HEALTH & SAFETY EXECUTIVE NUCLEAR DIRECTORATE ASSESSMENT REPORT

New Build

Step 2 EPR Civil Engineering and External Hazard Assessment

Figure 1 Comparison of EPR Design Spectra with various UK site Response Spectra

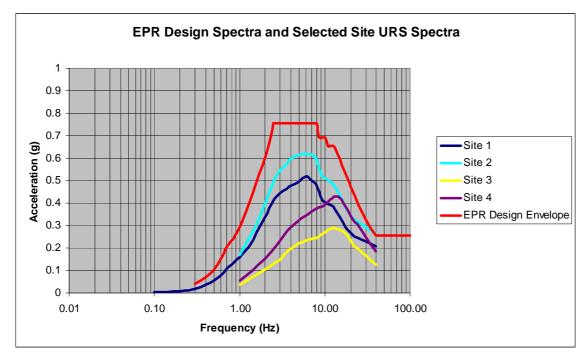
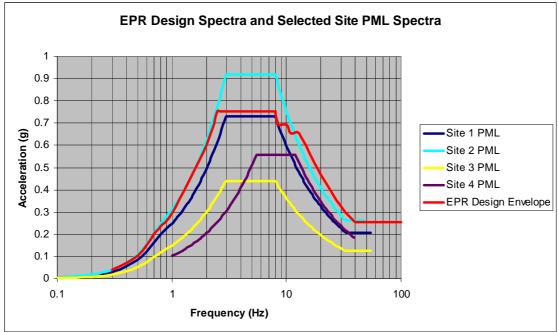
EDF/Areva claims that the UK-EPR design has addressed these SAPs, Ref 5. The documents supplied provide a clear statement over the design conditions applied to the plant and in addition identify those aspects which will require further consideration once a site or sites have been identified. The range of hazards considered is seen as reasonable. The current list of hazards recognises that some cannot be defined until a site (or sites) have been identified. For other hazards, limiting values are provided. It is claimed that consequential or secondary hazards are considered in the design process. The process for this will require greater scrutiny in Step 3. Figure 1 in this report shows a basic comparison of the seismic design basis for the UK-EPR as compared against a selection of 4 UK sites. As can be seen, it is not apparent that the design envelopes all sites from this simple comparison.
